Problem with 802.1ASds and Multiple Time Domains

Adriaan Niess, XC/EYA2, 2024-03-01

802.1ASds Fails with Multiple Time Domains

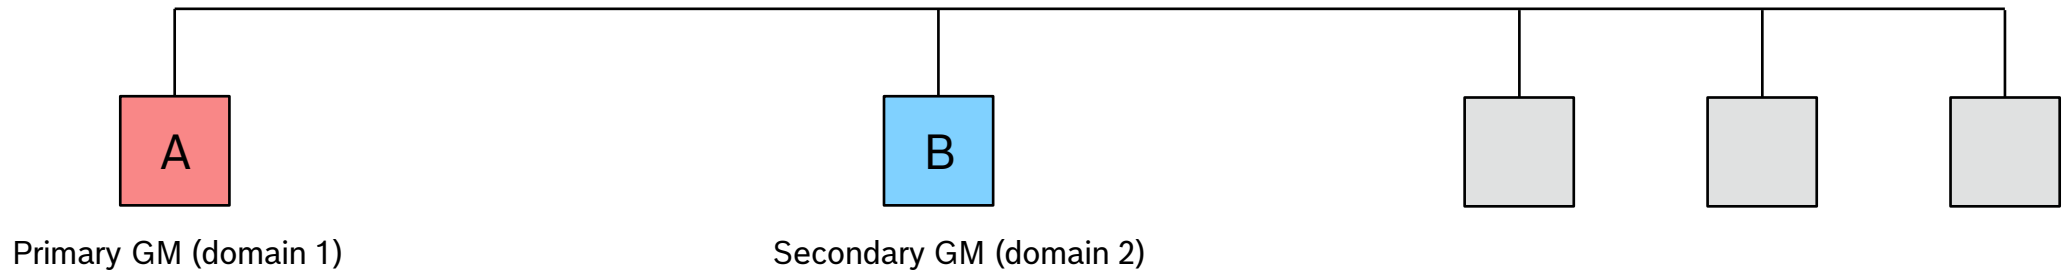
- Example Szenario shows if primary GM crashes on HDE link, it can also prevent the secondary GM from doing a failover. Essentially the secondary GM gets *deadlocked*.
- In general the problem can occur whenever a gPTP node is time receiver and time transmitter at the same time on different domains

Example Szenario (3)

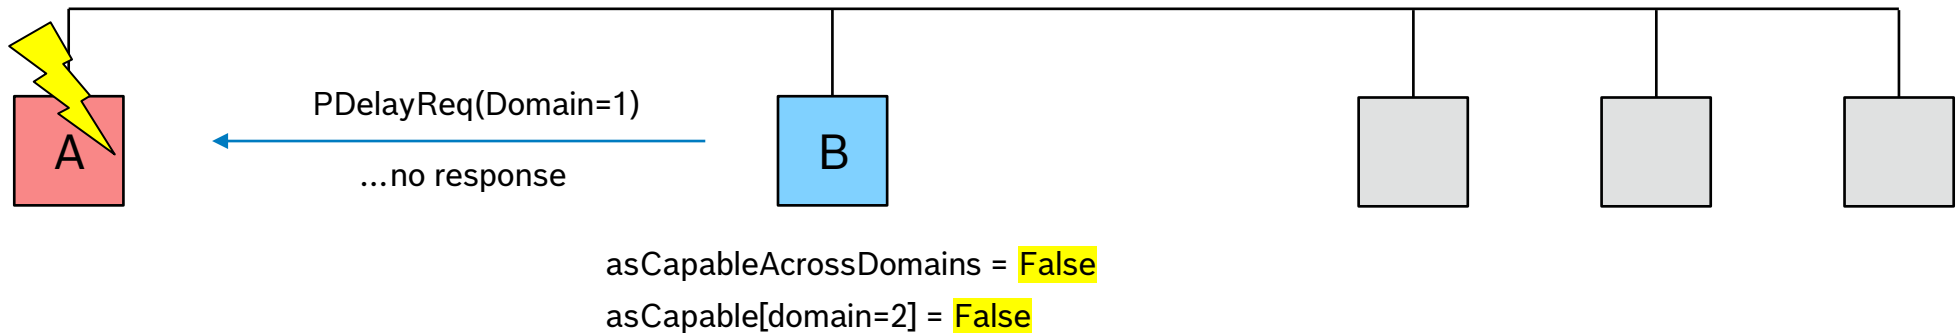
- Now the primary GM crashes
- **Domain 1 is now offline!**

asCapableAcrossDomains = True
asCapable[domain=2] = True
